CITY OF ALBUQUERQUE

Re: Certification Submittal for Final Building Certificate of Occupancy for
Gruet Winery, [C-18 / D002]
8400 Pan American Frwy NE
Engineer's Stamp Dated 06/27/08

RE: FINAL CERTIFICATION OF OCCUPANCY FOR GRUETWINERY ADDITION
(C18 / D12)

**GRUET WINERY ADDITION
GRADING AND DRAINAGE PLAN**

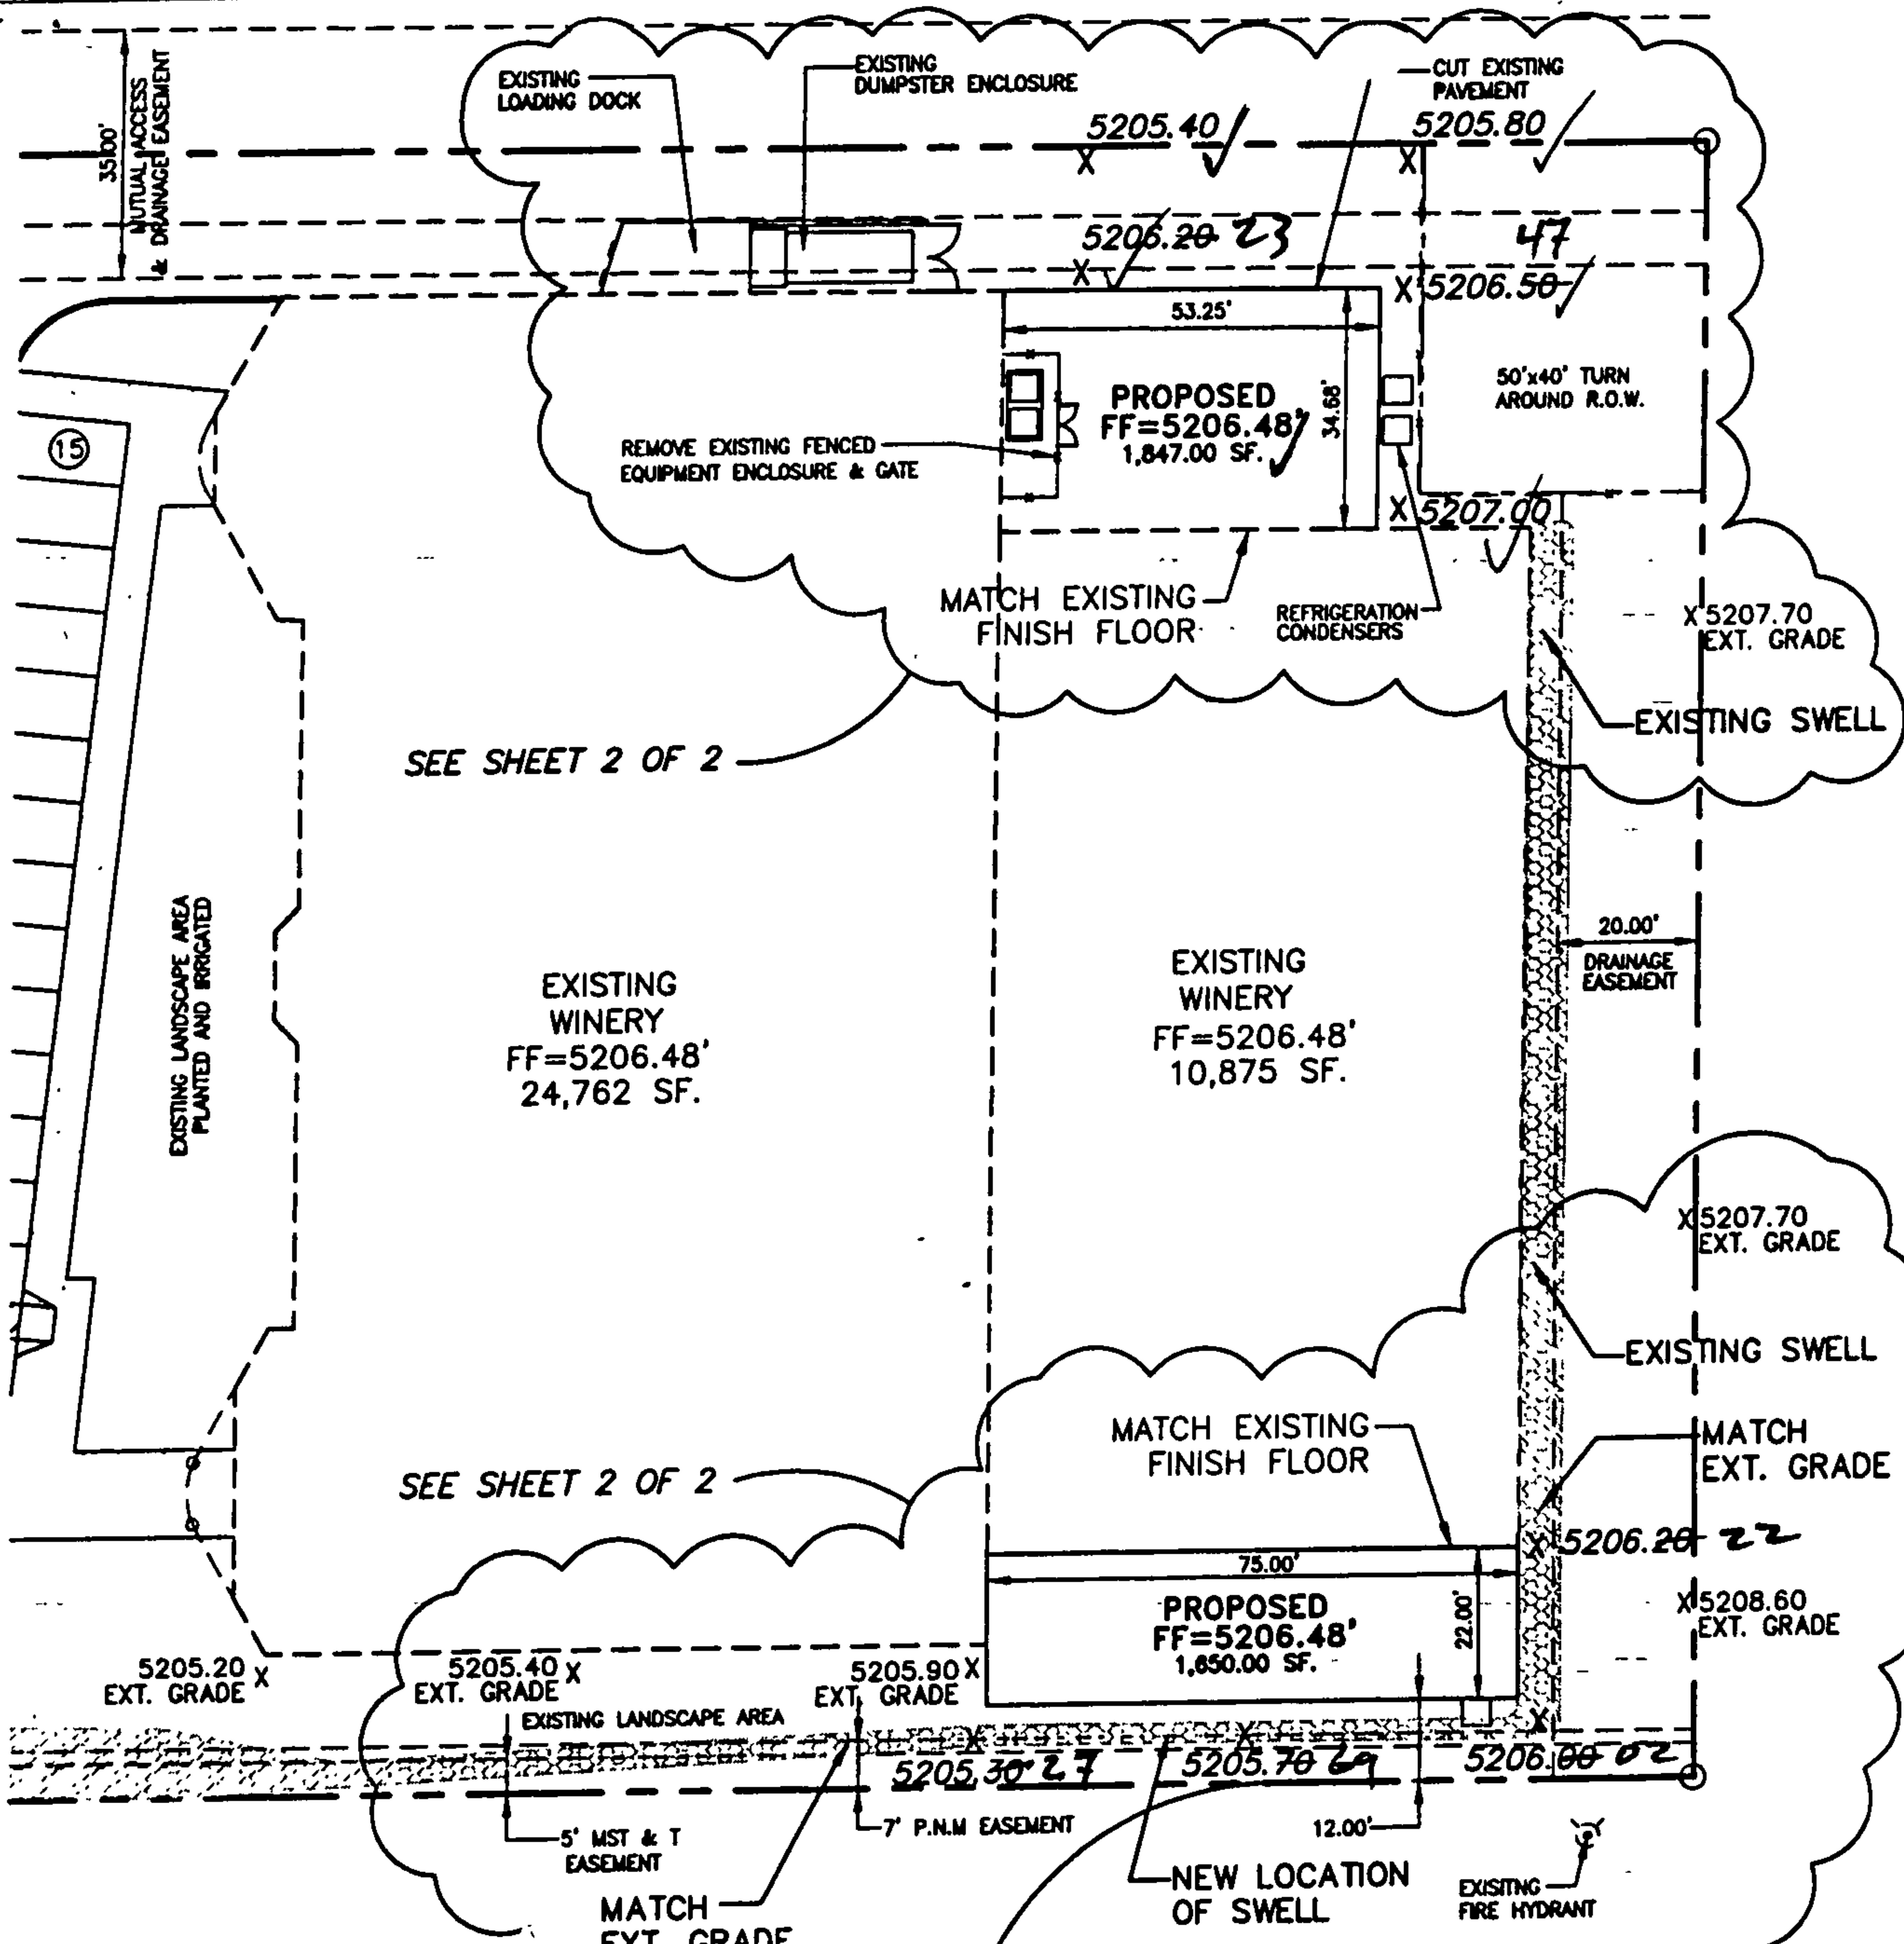
I, SHAHAB BIAZAR, NMPE 13479, OF THE FIRM ADVANCED ENGINEERING AND CONSULTING, LLC HEREBY CERTIFY THAT THIS PROJECT HAS BEEN GRADED AND WILL DRAIN IN SUBSTANTIAL COMPLIANCE WITH AND IN ACCORDANCE WITH THE DESIGN INTENT OF THE APPROVED PLAN DATED 06/06/2003. THE RECORD INFORMATION EDITED ONTO THE ORIGINAL DESIGN DOCUMENT HAS BEEN OBTAINED BY ME OR UNDER MY DIRECT SUPERVISION AND IS TRUE AND CORRECT TO THE BEST OF MY KNOWLEDGE AND BELIEF. THIS CERTIFICATION IS SUBMITTED IN SUPPORT OF A REQUEST FOR GRADING CERTIFICATION.
